La Jolla Shores Planned District Advisory Board (LJSPDAB)
APPLICANT PROJECT INFORMATION FORM

- Project Tracking System (PTS) Number/Accela "PRJ" Number and Project Name (only submitted projects to the Development Services Department can be heard as action items):
PRJ 1120759

Site Development Plans PRJ-1120759.pdf

LANDSCAPE AREA DIAGRAM

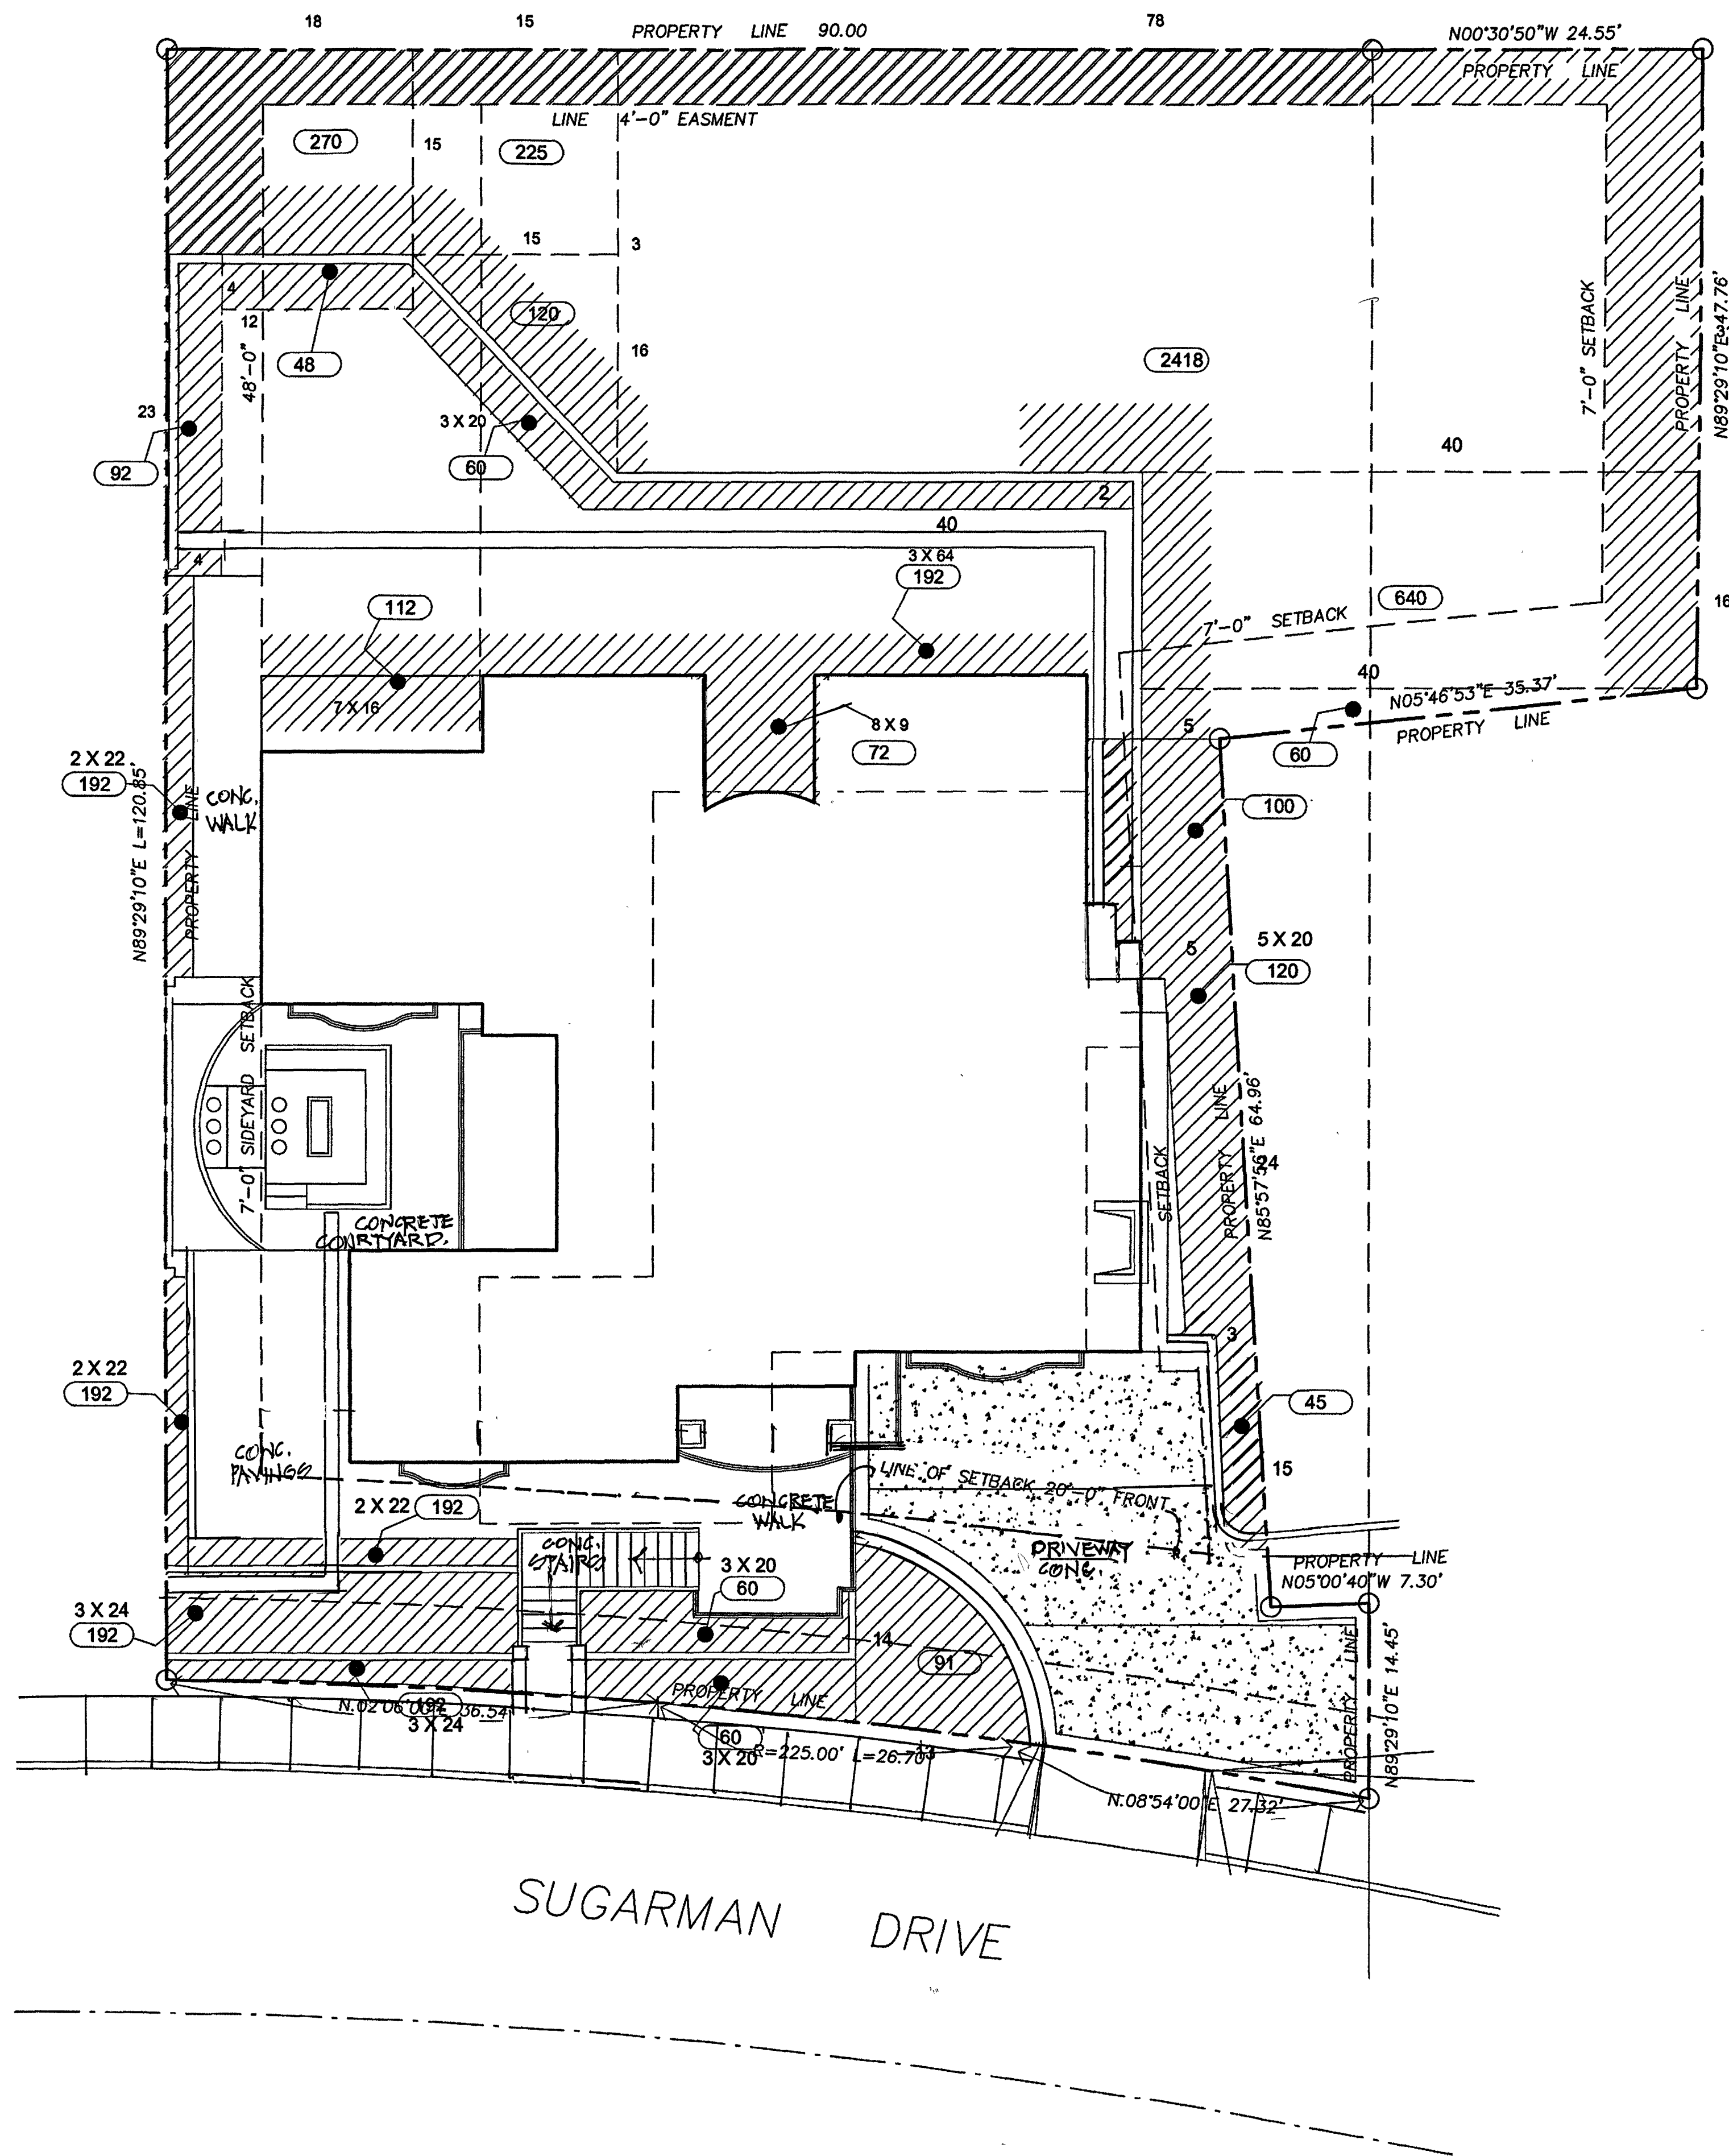
SHT. A10.0
Landscape Area Diagram [§ 1510.0304]: A minimum 30% of the total parcel area shall be landscaped. Please provide a landscape area diagram, separate from the Landscape Plan, which quantifies the site's landscape areas, planting areas, and hardscape areas. Provide square footages of each.

***Staff reviewed the area calculations on sheet A10 however, Proposed landscape appears to be on top of walls and hardscape. Please provide a legible landscape plan for staff review.

A12.0

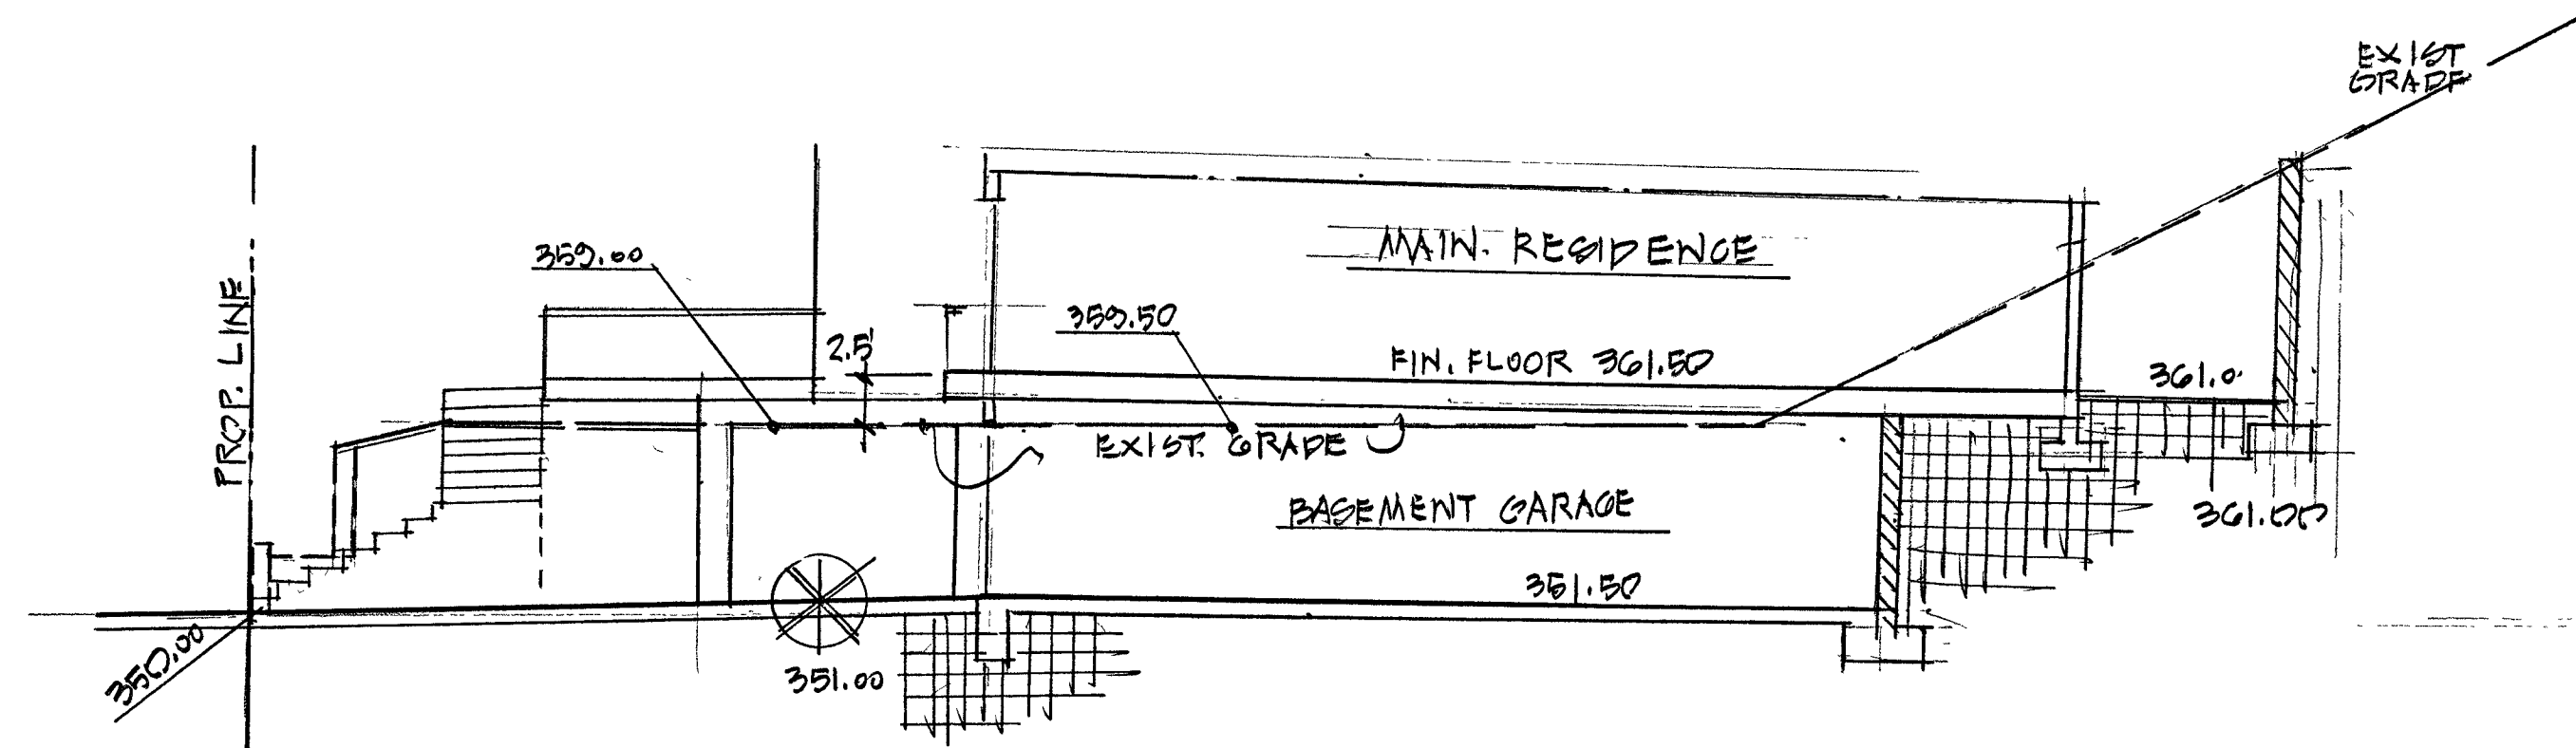
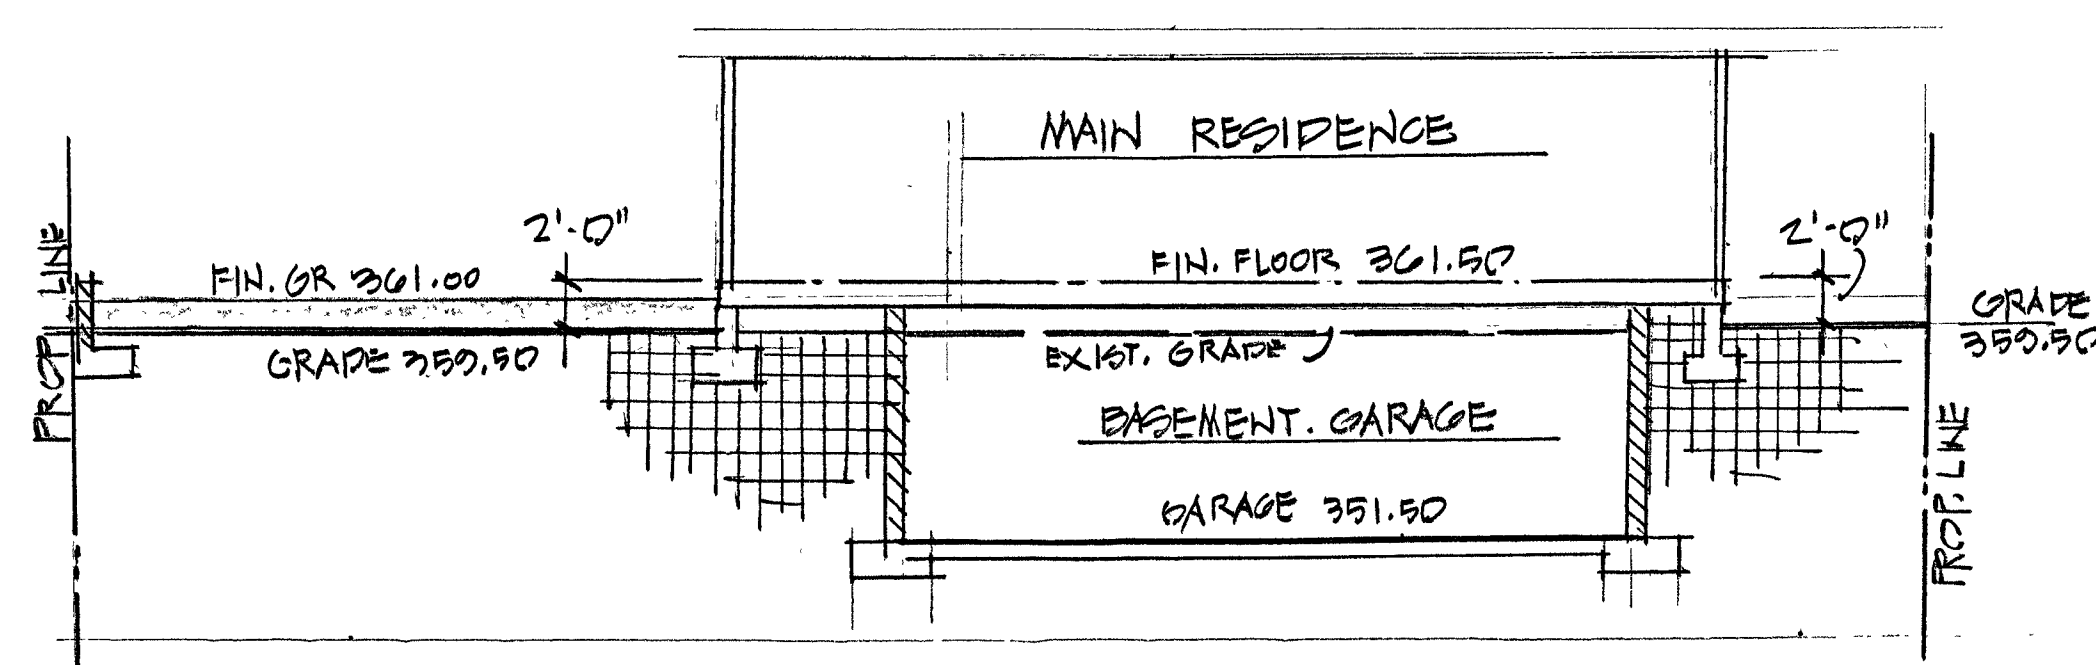
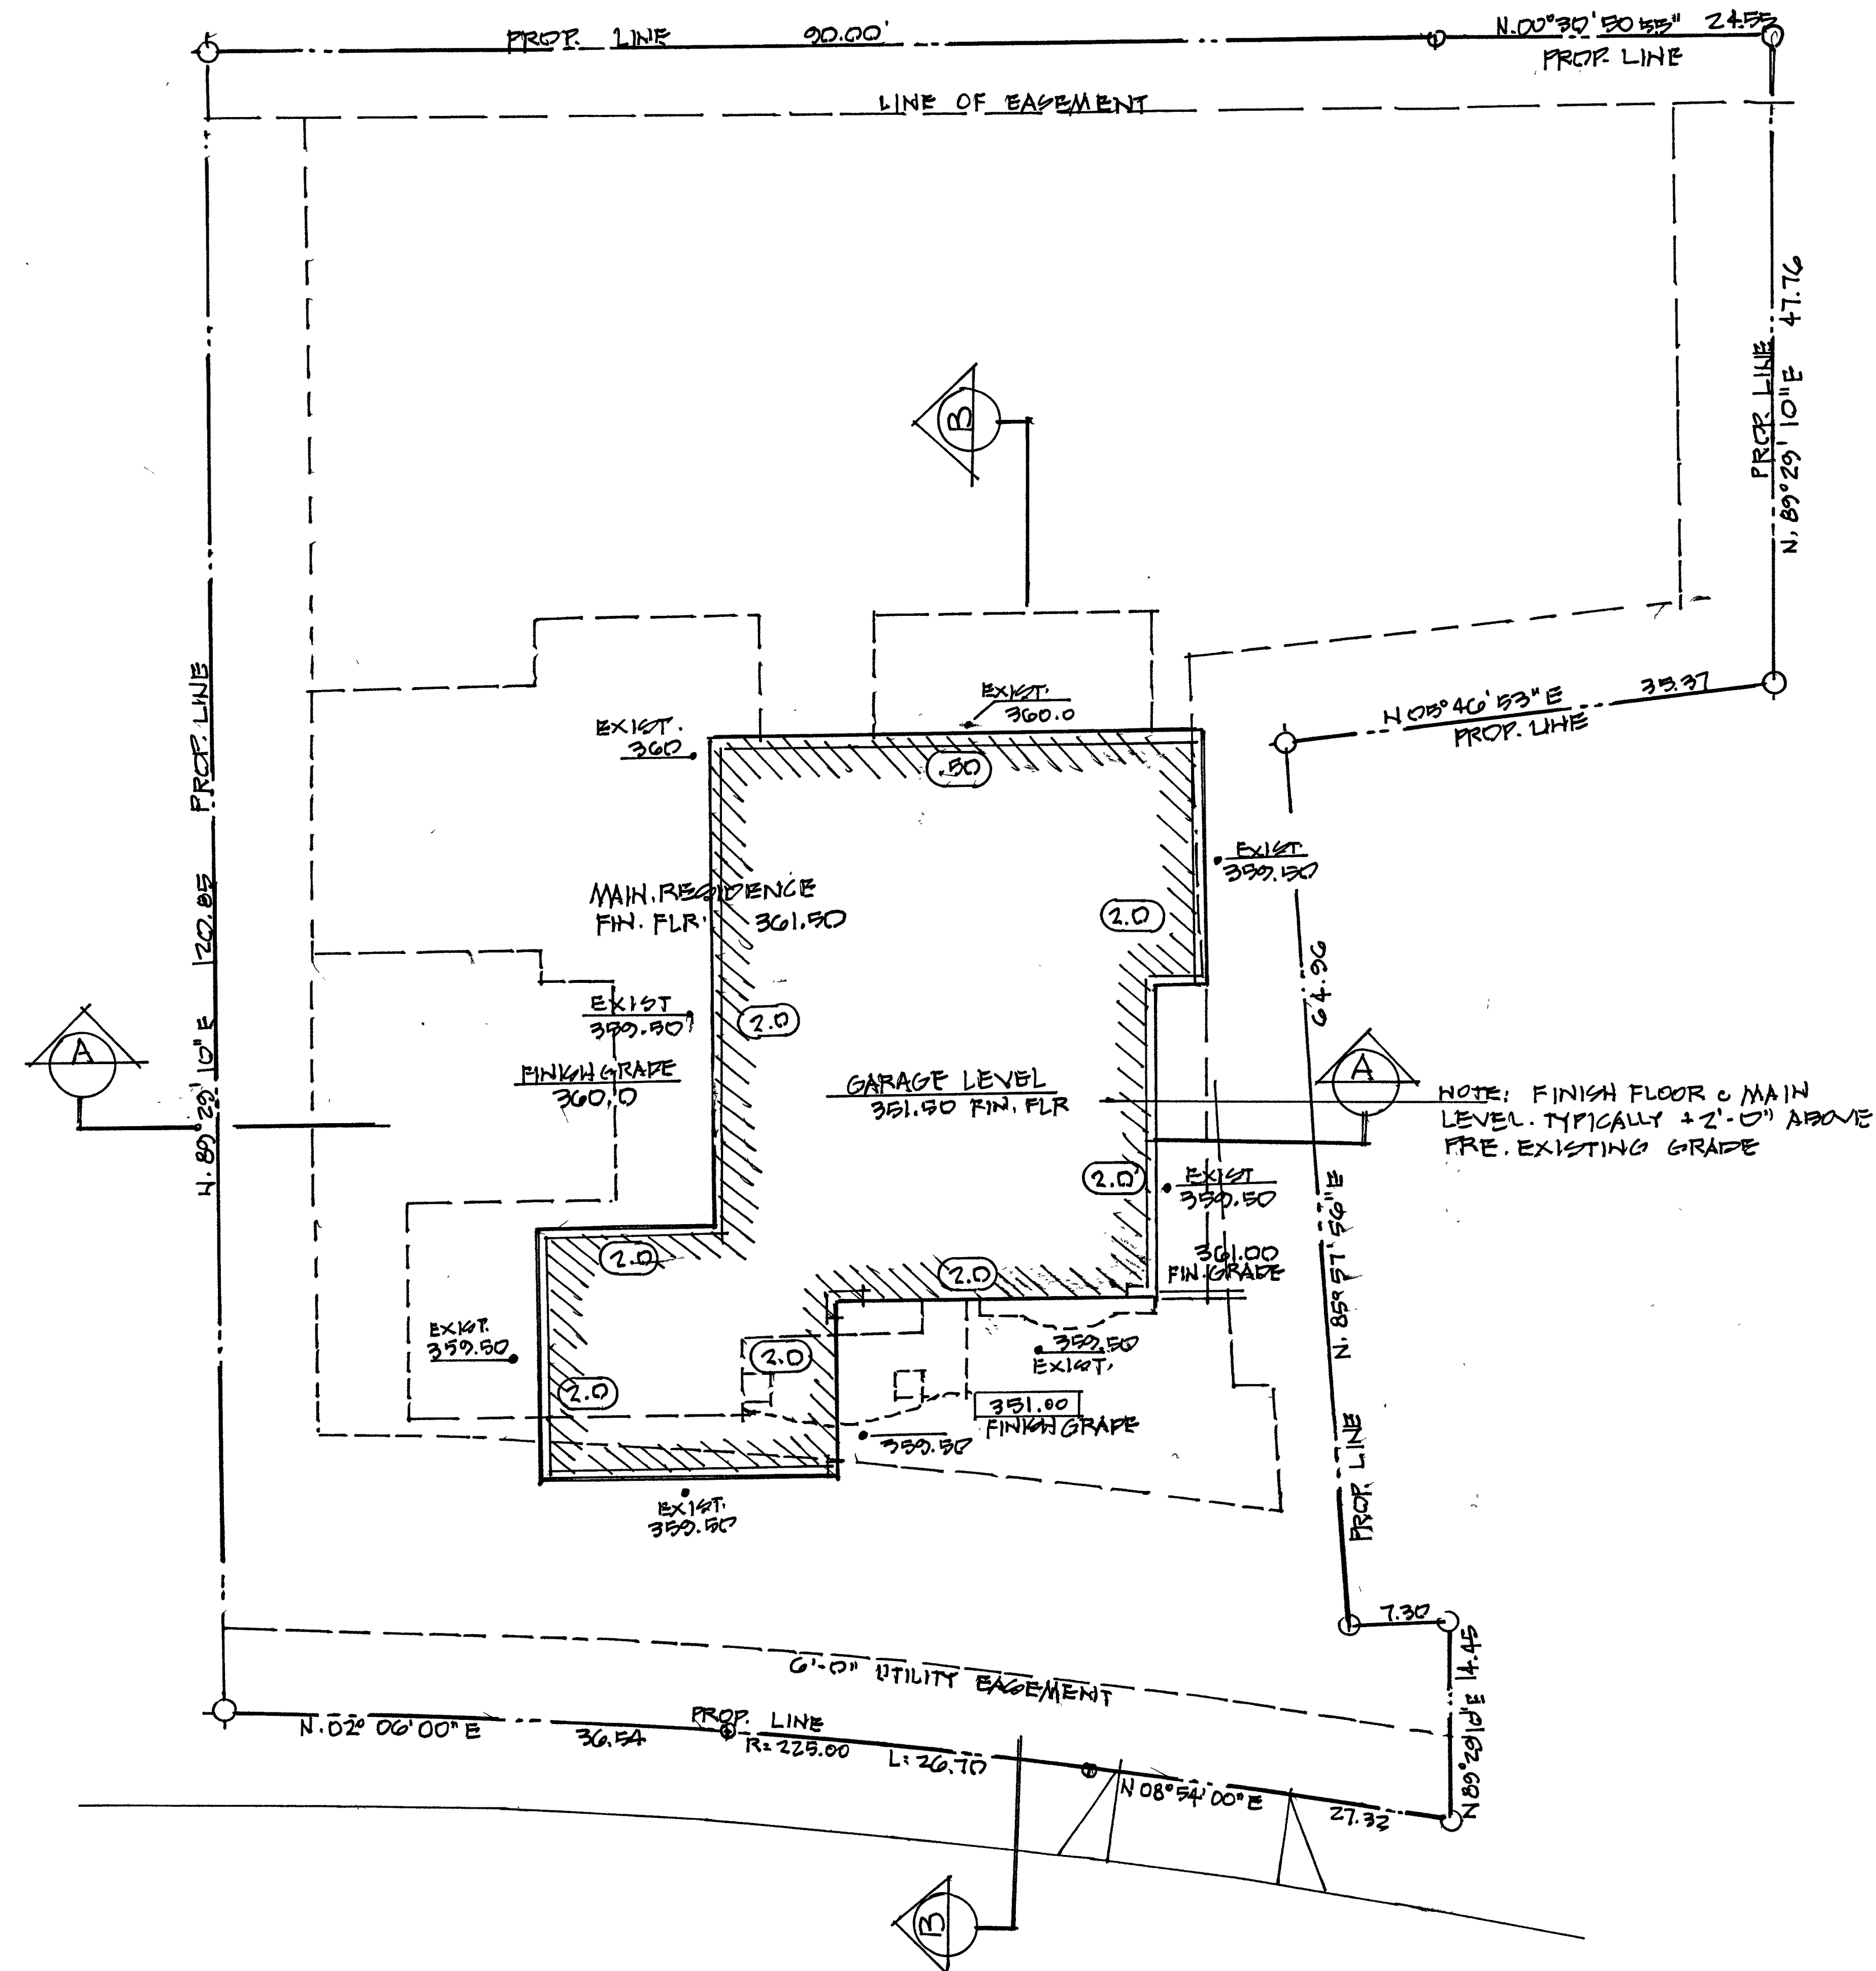
SEE A12.0 Please provide a slope analysis which demonstrates that the proposed project will not encroach more than the allowable percentage of the total lot area into the Steep Hillside in accordance with San Diego Municipal Code Section 143.0142(a)(2), (3), (4)(a), (c) and The City of San Diego Land Development Manual Steep Hillside Guidelines. The following information must be provided on the slope analysis:

1. Clearly indicate the location of all Steep Hillsides, defined as equal to or greater than 25% gradient slopes on the property. The natural sensitive slopes (areas not previously disturbed) should be calculated out, and properly illustrated on the plans. This information must be accurately displayed and match the information provided within the submitted geology report.

SEE A12.0 The subject property is outside of the Multiple Habitat Planning Area (MHPA), the allowable development area includes all portions of the premises without steep hillsides.
